# Access Compliance Report

## Public Rights-of-Way

### (Curb Ramps)

Intersection ID: 47832	Main Street: TOM_SHORT_RD	Cross Street: CAMP_VERDE_LN	Location: SE
ADA ID: 70FD7438D2E6	Ramp Type: BlendTrans1	Initial Pass/Fail: Fail	Overall Compliance: No
Severity Score: 8.75			
Codes/Mitigation Info/Possible Solution		Field Measurements/Component Compliance

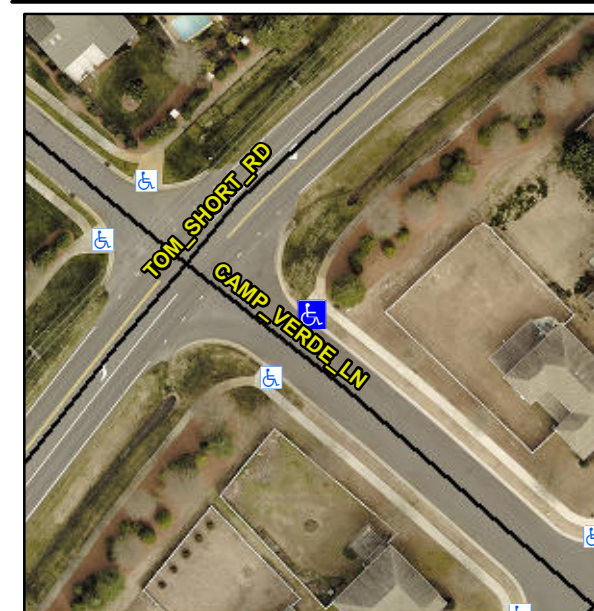
**Not Found, R304.5.1**

Compliance	Description	Data	Compliance	Description	Data
N/A	Ramp Length (in)	58.0	Yes	BlendTrans Slope (%)	4.0
No	Ramp Width (in)	47.0	Yes	BlendTrans XSlope (%)	0.9
N/A	Flare Type LT	N/A	N/A	Flare Type RT	N/A
N/A	Flare Slope LT (%)	N/A	N/A	Flare Slope RT (%)	N/A
N/A	Flare Traversable LT?	N/A	N/A	Flare Traversable RT?	N/A
N/A	Landing Length (in)	N/A	N/A	DWS Provided?	N/A
N/A	Landing Width (in)	N/A	N/A	DWS Contrast?	N/A
N/A	Landing Slope (%)	N/A	N/A	DWS Length (in)	N/A
N/A	Landing X Slope (%)	N/A	N/A	DWS Full Width?	N/A
N/A	Landing Curb? (Y/N)	N/A	N/A	DWS Offset (in)	N/A
N/A	Shared Landing?	N/A			
N/A	Gutter Ponding?	N/A	N/A	Gutter Slope (%)	N/A
N/A	Gutter Lip Ht (in)	N/A	N/A	Gutter X Slope (%)	N/A
N/A	Painted X Walk1?	No	N/A	Painted X Walk2?	N/A
	X Walk 1 Direction	To SW		X Walk 2 Direction	N/A
	X Walk 1 Width (in)	N/A		X Walk 2 Width (in)	N/A
	X Walk 1 Slope (%)	2.0		X Walk 2 Slope (%)	N/A
	X Walk 1 X Slope (%)	0.1		X Walk 2 X Slope (%)	N/A

N/A	Ramp inside XWalk1?	N/A	N/A	Ramp inside XWalk2?	N/A
	Road Slope (%)	0.1		Clear Space?	N/A
	Road X Slope (%)	2.0	N/A	Clear Space to XWalk (in)	N/A
N/A	Any Obstructions?	N/A	N/A	Storm Grate/Utility Hazard?	N/A
	Obstruction Type			Storm Grate/Utility Type	
		N/A			N/A
			Yes	Surface Condition? (G/P)	Good
			No	Curb Slope (%)	6.3

**Remove & Replace Curb Ramp With Two New Directional Ramps or Equivalent.**
